Hassell

URBAN DESIGN REVIEW WATERLOO ESTATE SOUTH

1.	Introduction	3
2.	Place Analysis	9
3.	Observations on the Planning Proposal	33
4.	Technical Analysis of Planning Proposal	67
5.	Recommendations Summary	133
6.	Peer Review	151
7.	Appendices	
	Design guideline drawings	157
	Shadow drawings	201
	Area schedule	205

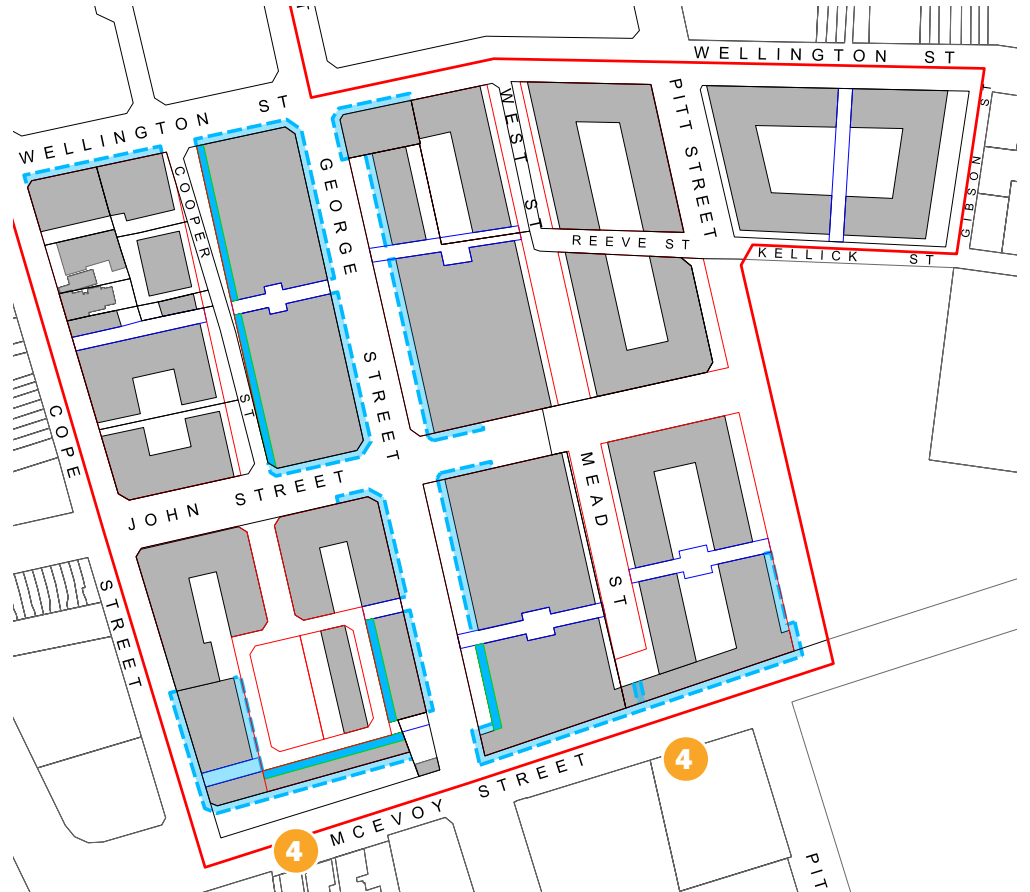
1. Extension of active frontage of the 2 lane ways to the east of George Street does not connect to the street beyond.
2. Active frontage east of McEvoy Street is very close to the busy road.
3. No active frontage to the built form adjacent to the small south east park.
4. Awnings are allocated below tower to levitate the effect of down draft wind.
5. Solar access to open spaces (streets, parks, courtyards etc) within in the precinct could be compromised by tall and long buildings, creating cold and dark conditions during winter.

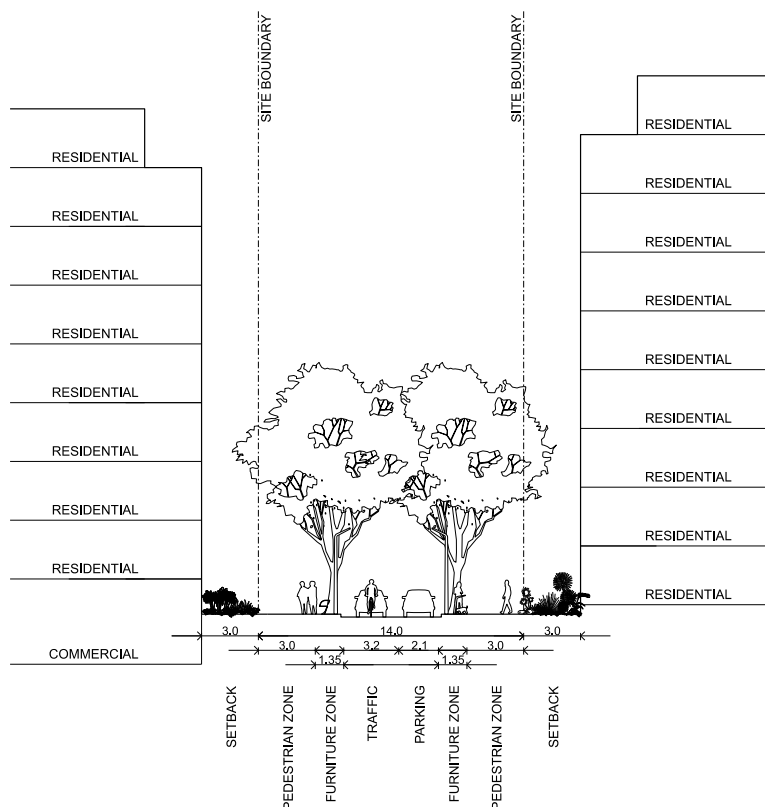
1. Setbacks should relate to use, thermal comfort, opportunities for existing tree retention etc.
2. Inconsistent application along Pitt Street
3. East and west blocks of McEvoy Street have inconsistent setbacks. No setback provision to the eastern block to allow tree retention.

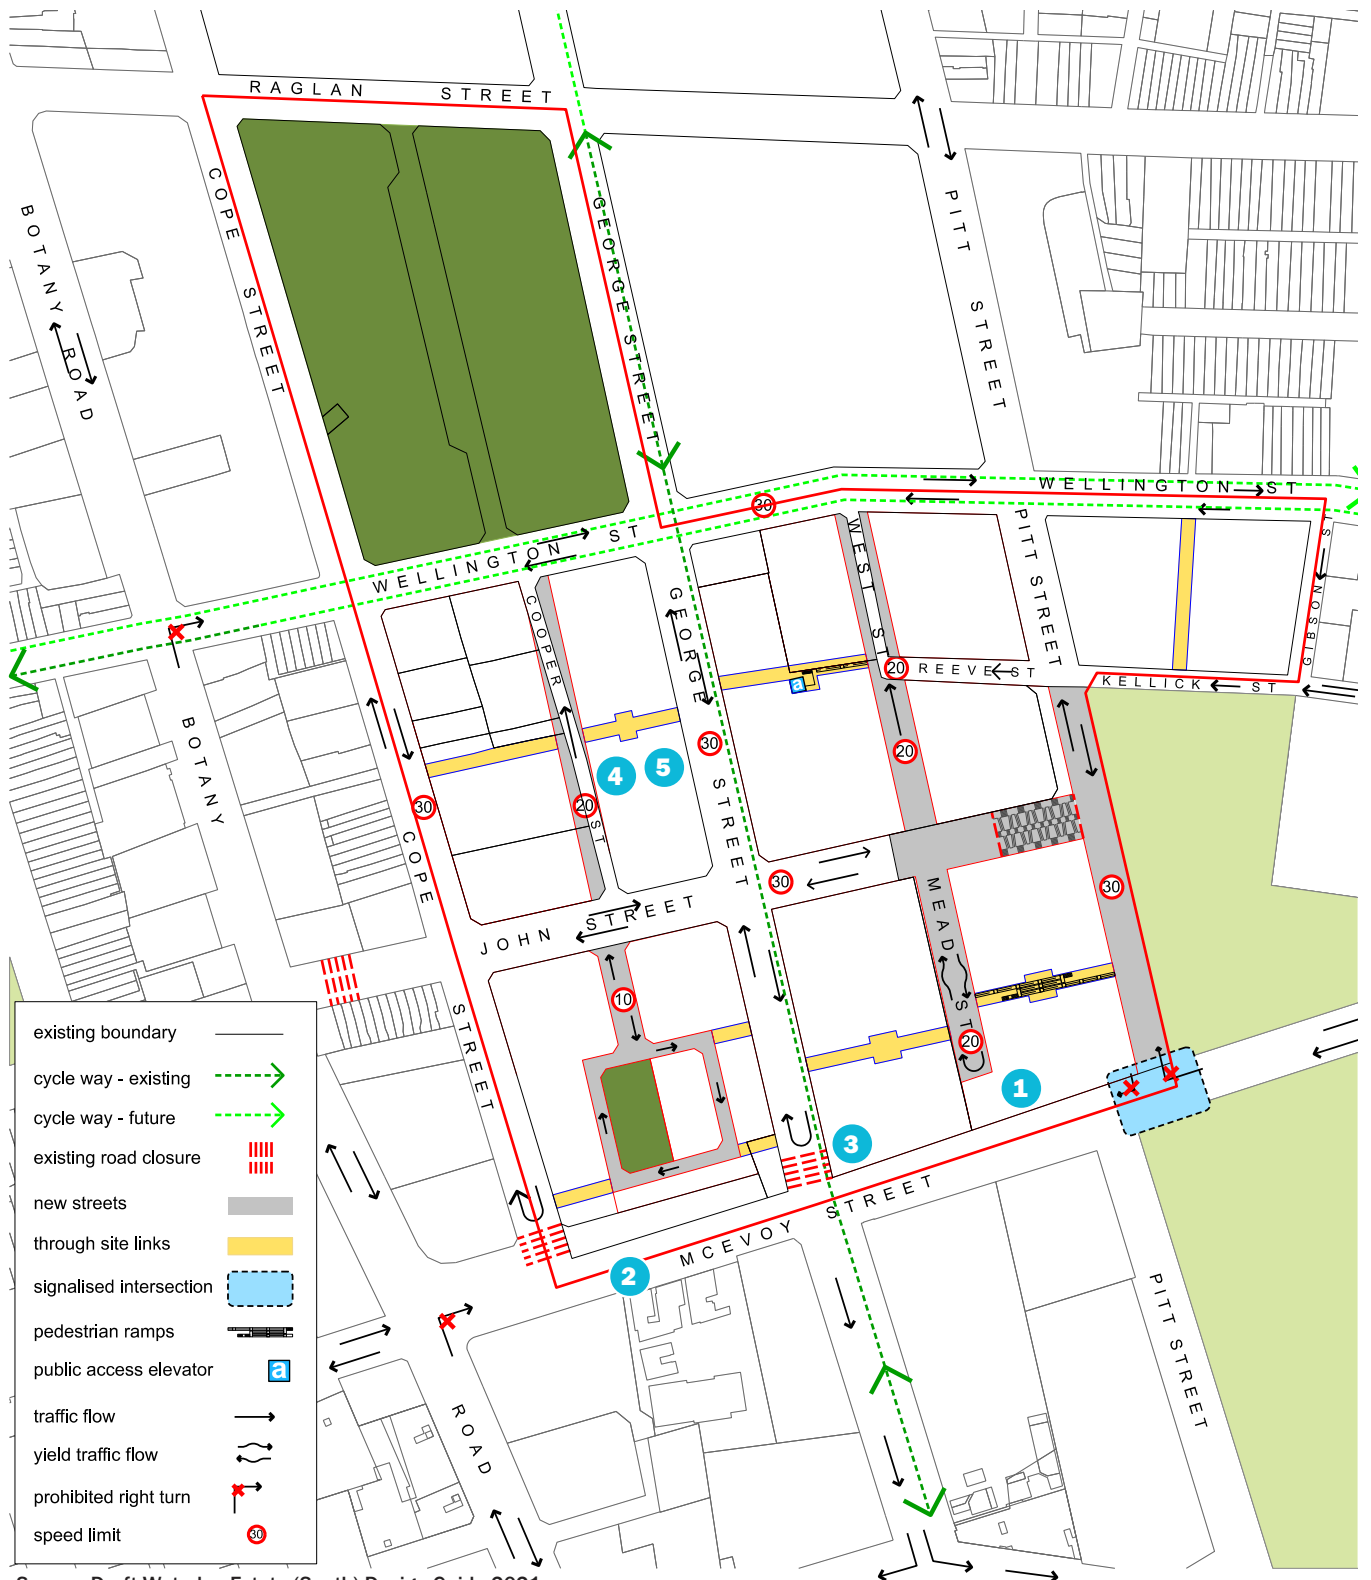
1. The proposed street blocks knit Waterloo South into its urban context and replace former streets that existed prior to its creation as a public housing precinct.
2. No provision for pedestrian connection from Mead Street through to McEvoy Street.
3. No provision for pedestrian connection from small park through to McEvoy Street.
4. Vehicular connection blocked from George Street to McEvoy Street - CoS Planning Proposal notes that the blocked entry from McEvoy Street is to avoid 'rat runs' through precinct. Pedestrian and cycle permeability at this intersection is provided.
5. The location of mid block links provide additional permeability to long street blocks, and are appropriately located.
6. The character of the mid block connections requires careful design attention owing to the scale of adjacent buildings.
7. Mid block links need to be designed to accommodate CPTED principles

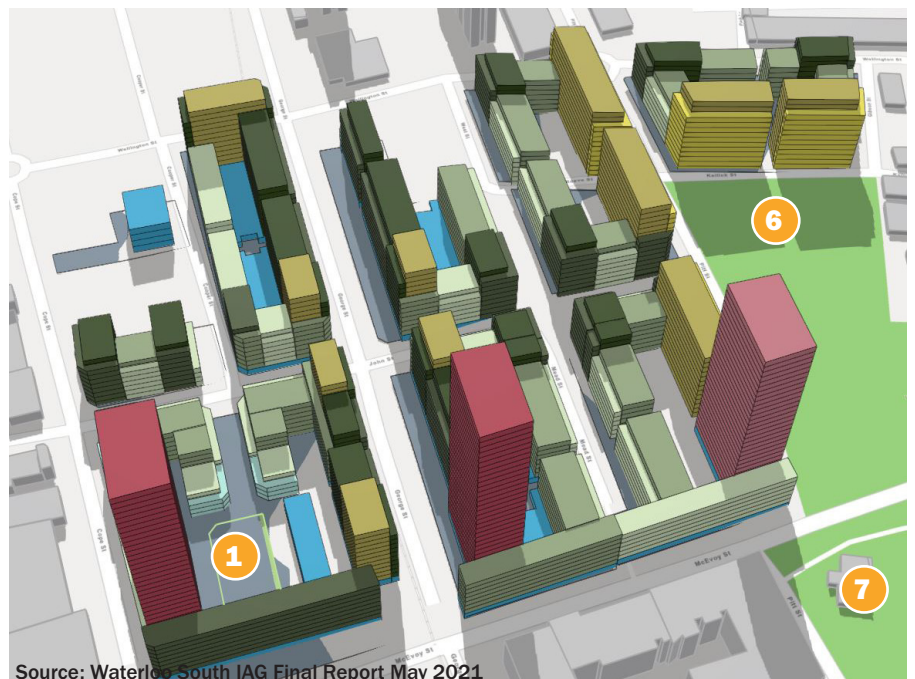
1. Location of smaller park to the south west is very contained. Solar access to the park is potentially impacted by the surrounding building mass.

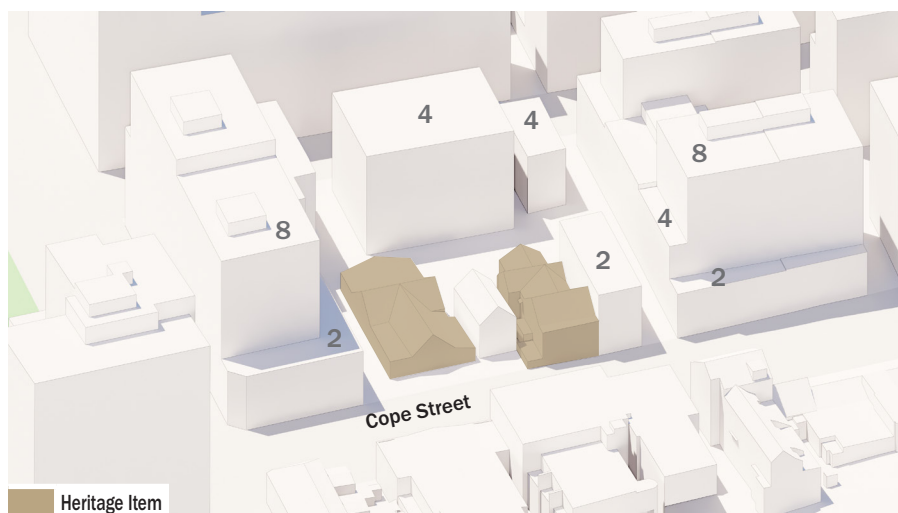
The proposal built form around the heritage terraces on the northern end of Cope Street are of small scale. Sets an appropriate height and transition to the taller buildings further away.

The proposed height to the north of the heritage items will create additional overshadowing between 9:00am and 3:00pm mid winter, resulting in the POS and potentially living room to receive less than 2 hour direct solar between 9:00am and 3:00pm mid winter.

5. Waterloo Park

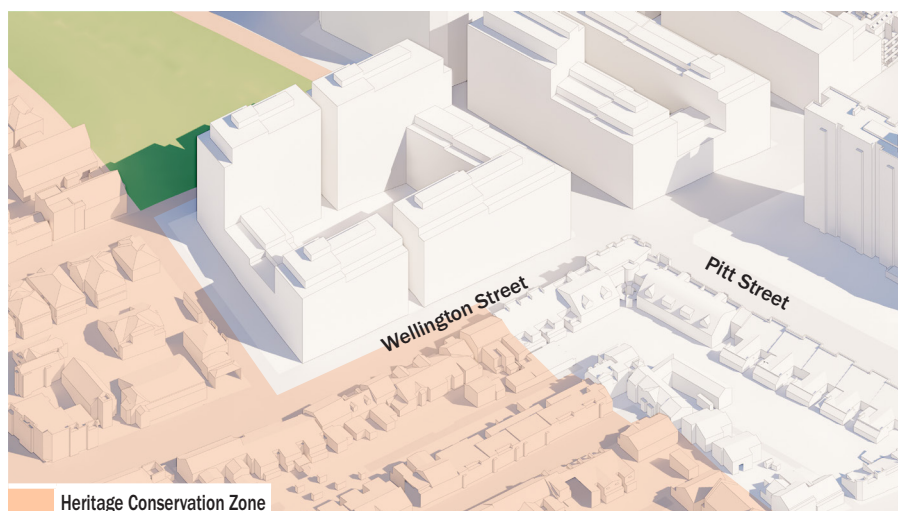
The built form around Waterloo Park should be designed to ensure adequate sun access to the park in mid winter, as well as to adjacent residential properties. Additional tree retention within this north western street block would further improve the development interface to the small scale residential houses.

Proposed section through George Street west block

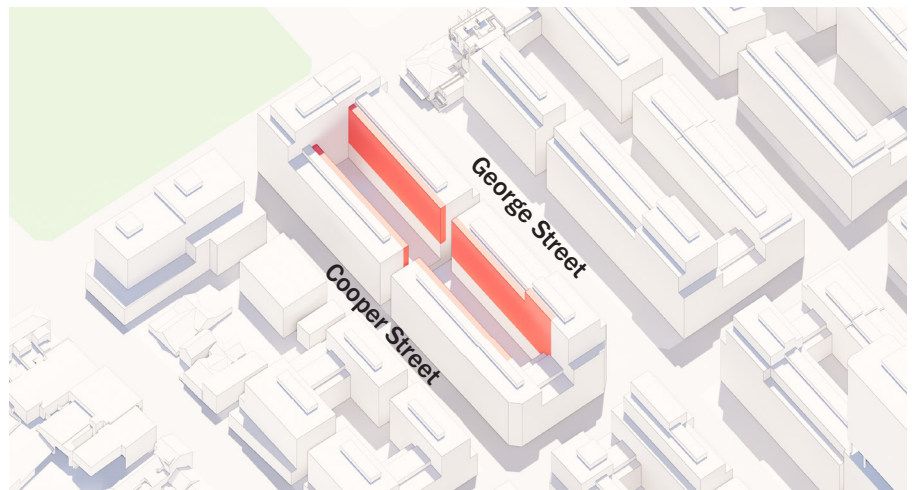
Proposed section through George Street west block with ADG compliant building separation

Winter Solstice

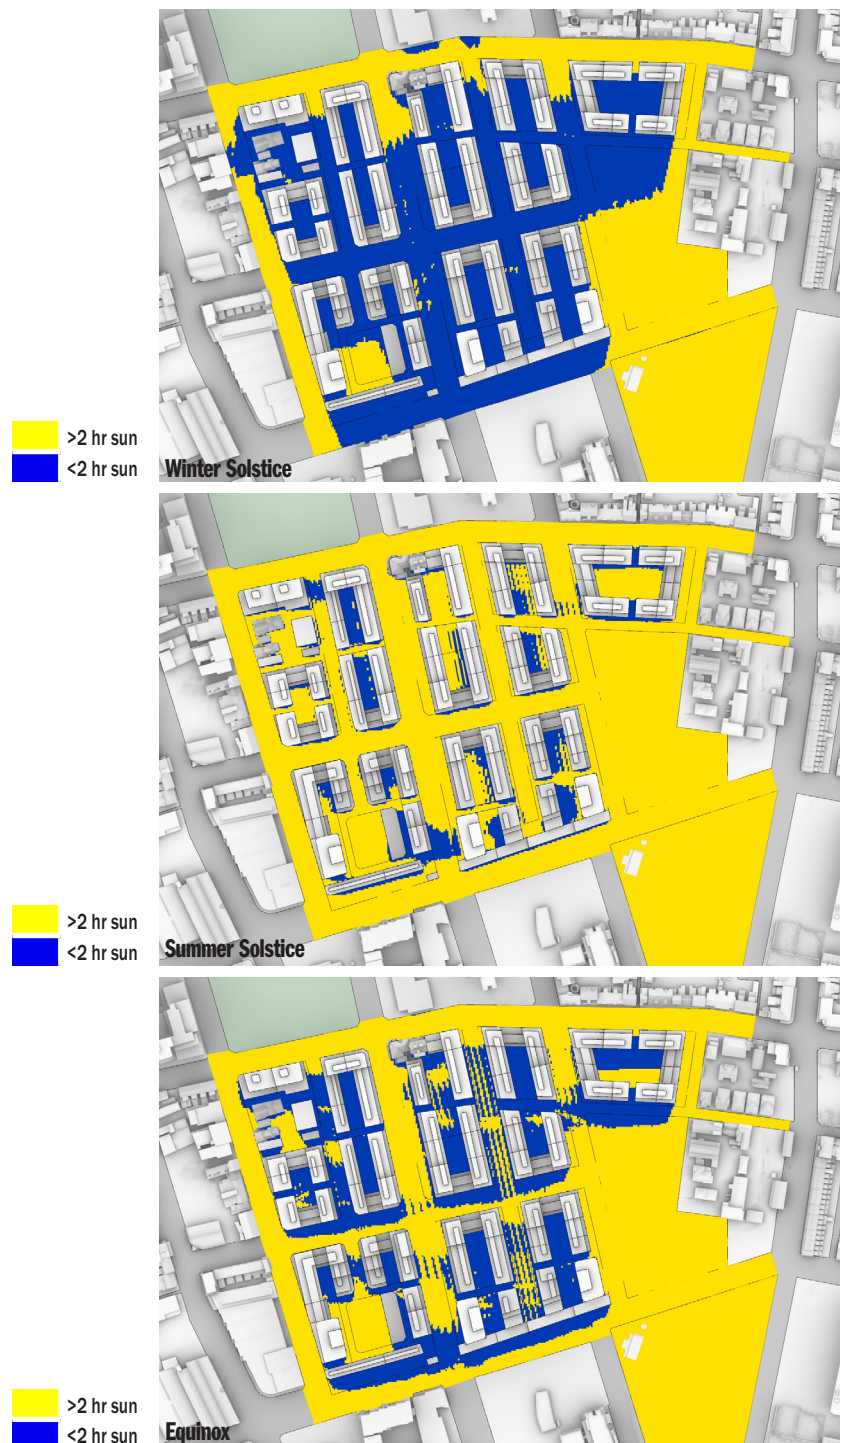
1. All shared courtyard spaces within the perimeter building blocks do not receive a minimum of 2 hour solar access between 9am-3pm mid winter
2. The majority of George Street, Mead Street, West Street, John Street and Cooper Street have minimal access to sunlight between 9am-3pm mid winter.
3. The south west park has good solar access mid winter.

Winter Solstice

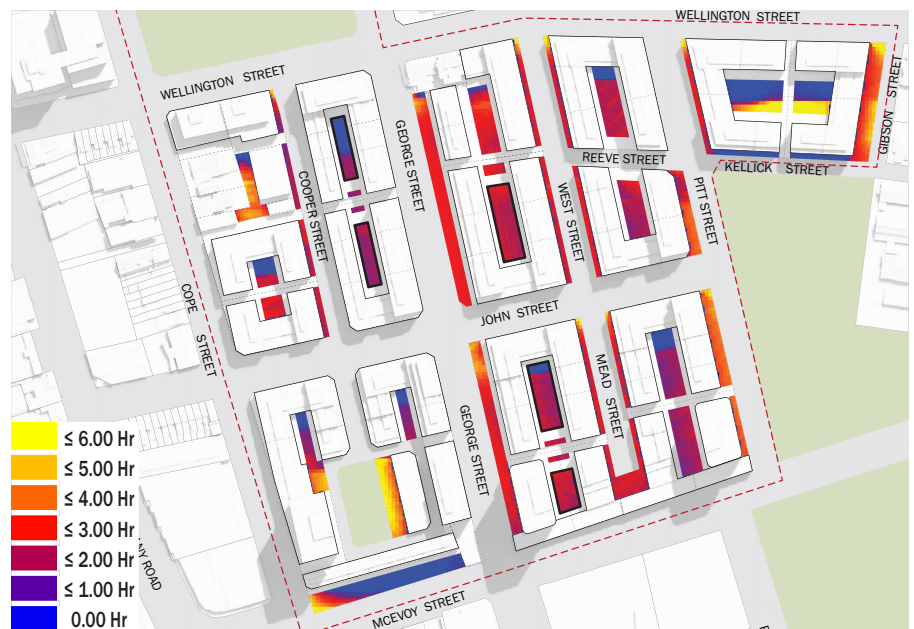
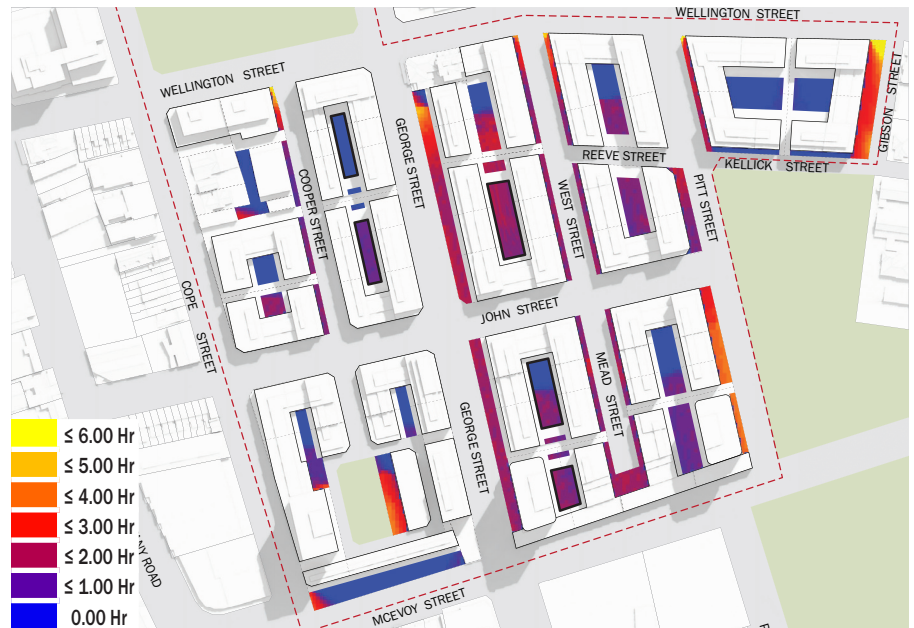
1. All shared courtyard spaces with deep soil zones within the perimeter building blocks receives less than 2 hour solar access, some less than 1 hour.
2. The majority of George Street, Mead Street, West Street and Cooper Street have minimal access to sunlight
3. Pitt Street north and Kellick Street also have minimal access to sunlight.

Planning Proposal

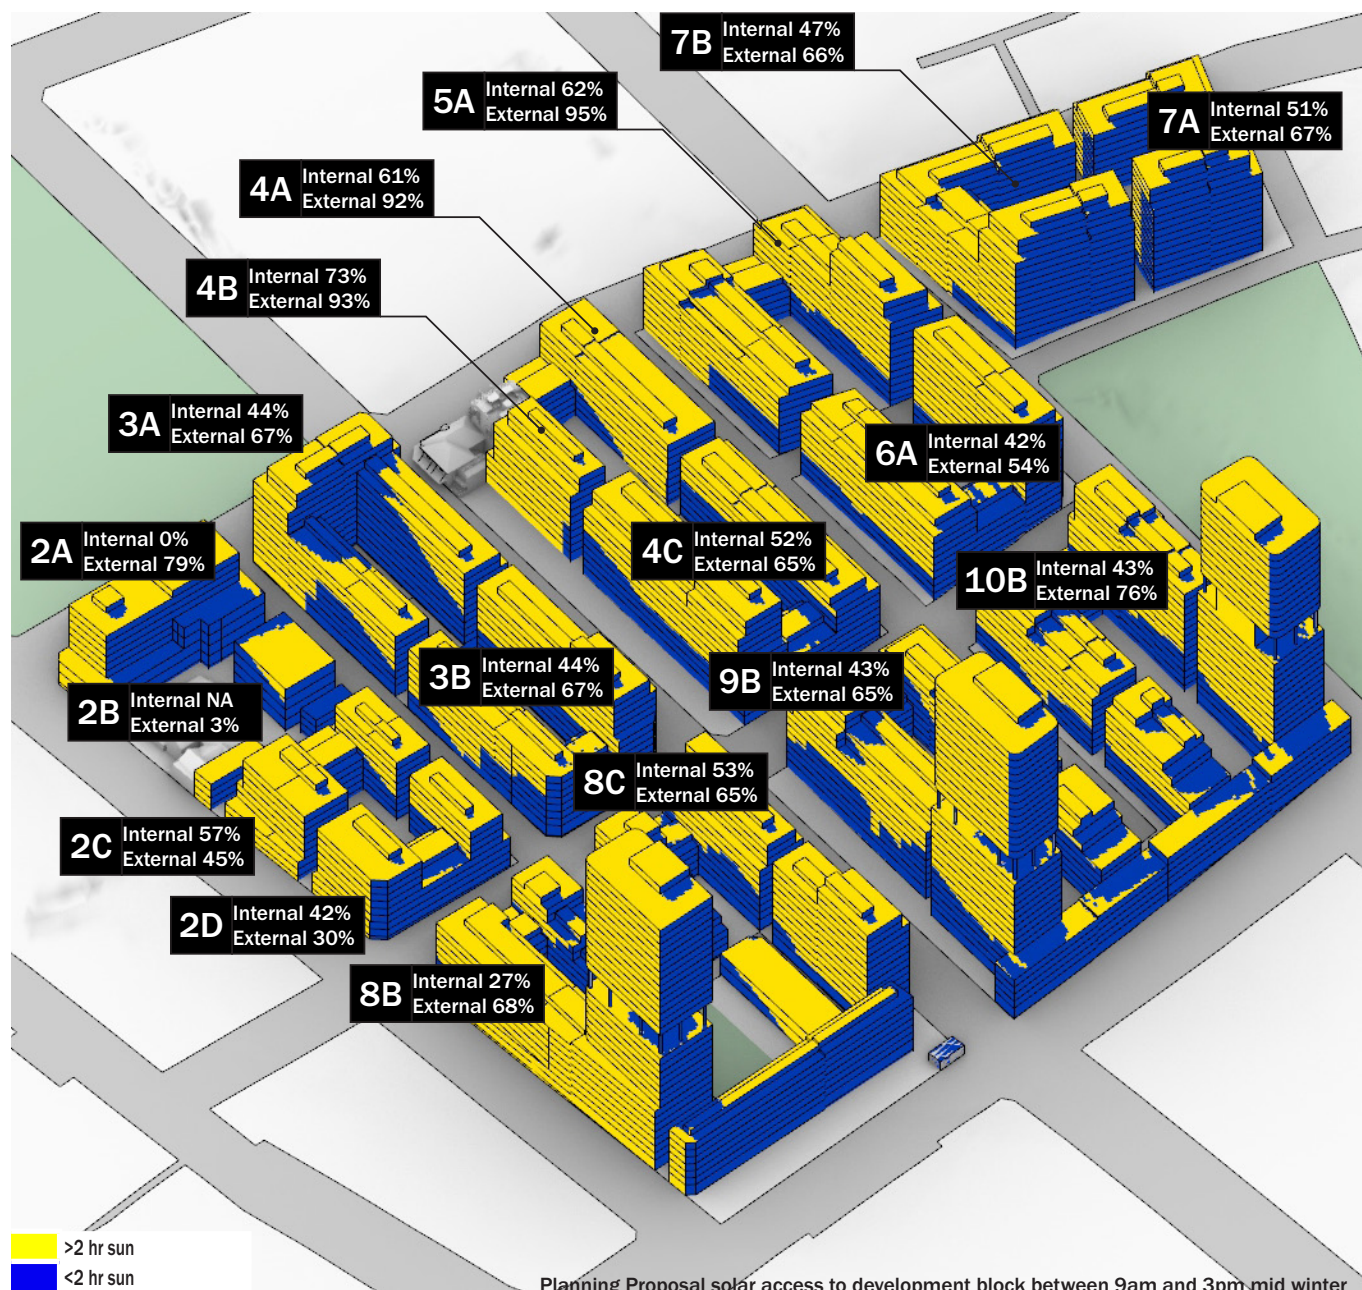
- Due to the height of the buildings proposed, the facade of the buildings are self shaded and overshadowed by adjacent buildings.
- The blocks in the centre of the precinct are the most impacted.
- The external percentage demonstrates in particular the east and west facades where the living rooms and POS will likely be located and the likelihood of compliance.
